KURT ALLEN FISHER
REDACTED
Salt Lake City, Utah 84147-0753
REDACTED
REDACTED
May 24, 2019

Holly Mullen, Communications and Engagement Manager
SALT LAKE CITY DEPARTMENT OF PUBLIC UTILITIES
1530 South West Temple
Salt Lake City, UT 84115

Re: Second Comment by Kurt A. Fisher on 4th Avenue Well Chemical Treatment Plant
Securing the sodium hypochlorite tank against seismic risk; Option 2c location
alternative design

Figure 4- Concept schematic of the proposed facility from above and side.

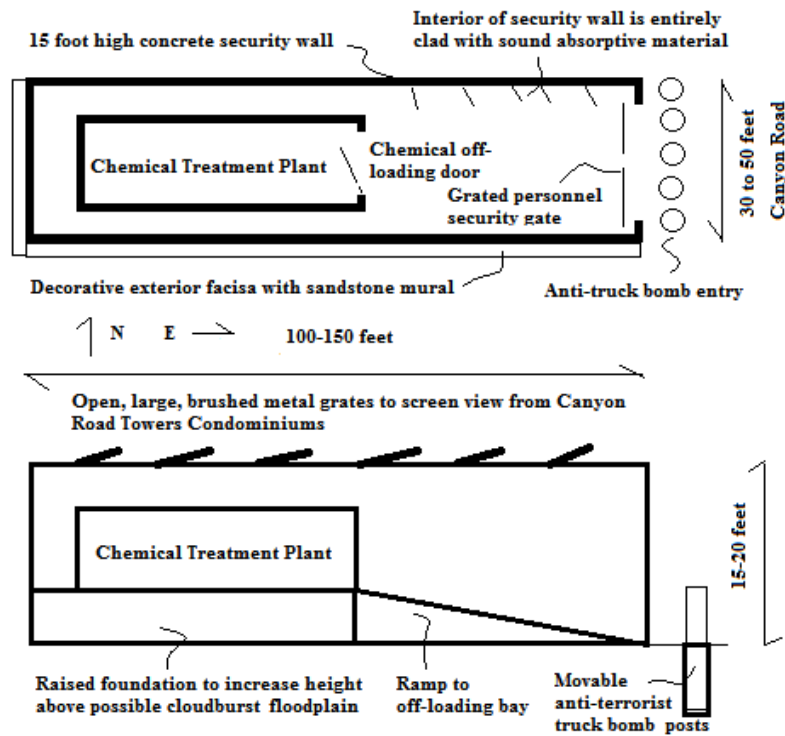
Figure 4 illustrates an anti-terrorist facility that is more resilient than the DPU's current concept design. Aesthetic features to make the facility better blend in with City Creek Park and the surrounding neighborhood include:

- An exterior decorative fascia on the exterior south and west walls with a sandstone mural depicting animals still commonly seen in City Creek Canyon, *e.g.* – Rocky Mountain elk, moose, eagles, falcons, mountain lions and coyotes.
- The interior would be clad with sound absorptive tiling.
- The top of the security enclosure would consist of wide open grates of brushed metal with the bottoms also clad in a sound absorbing material (not shown in figure). This open roof would screen the interior of the facility from the Canyon Tower Condominiums and summer tourists walking up State Street.
- Not shown in the schematic are removable stone ports around the exterior perimeter to allow firefighters to put water on the facility without having to enter the enclosure.
